Groundwater Transfer Review Summary Form

Transfer/PA # T- <u>14275</u>

OREGON				Ground Water Review Form:			
		gon Water Resou Summer Street NE	-	🖂 Water Right Transfer			
WATER RESOURCES	Sale	alem, Oregon 97301-1271		Permit Amendment			
D E P A R T M E N T	(503) 986-0900 www.wrd.state.or.us			□ GR Modification			
				□ Other			
Application: T- <u>1</u>	4275	5	Applicant Name: Klamath Falls RV Resort LLC				
Proposed Chang	es:	🛛 POA	□ APOA	□ SW→GW	\boxtimes RA		
		🖾 USE	🛛 POU	\Box other			
Reviewer(s): <u>Steve Ahlquist</u>				Date of Review: <u>9/20/2024</u>			
				Date Returned to WRSD: 9/20/2024			
The information	prov	vided in the ap	plication is insu	ifficient to evaluate	whether the prop	osed

Well Location Map

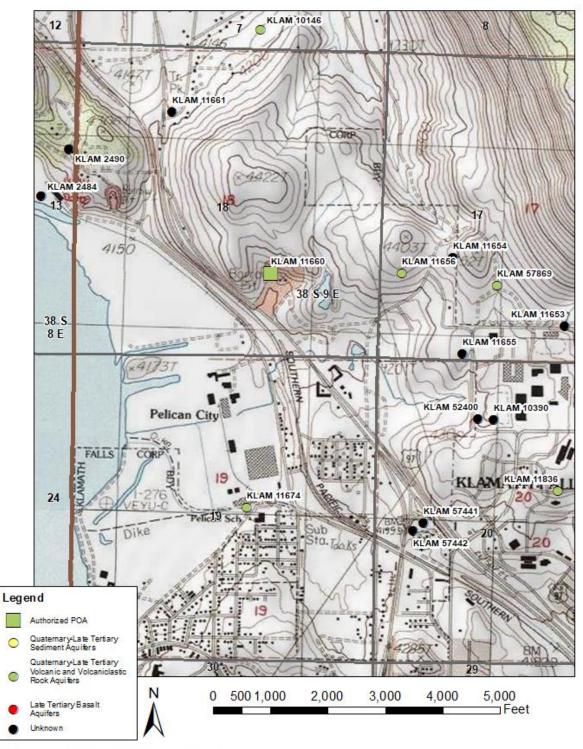
- change the POU for 0.81 acres to be used for primary irrigation.
 - correct the location of the authorized POA (KLAM 11660). The corrected location is approximately 120 feet northwest of the metes-and-bounds location description listed in Certificate 93607.

- 2. Will the proposed POA develop the same aquifer (source) as the existing authorized POA? ⊠ Yes □ No Comments: <u>The applicant has requested to correct the location of the</u> <u>authorized POA (KLAM 11660). KLAM 11660 will remain as the sole authorized POA.</u>
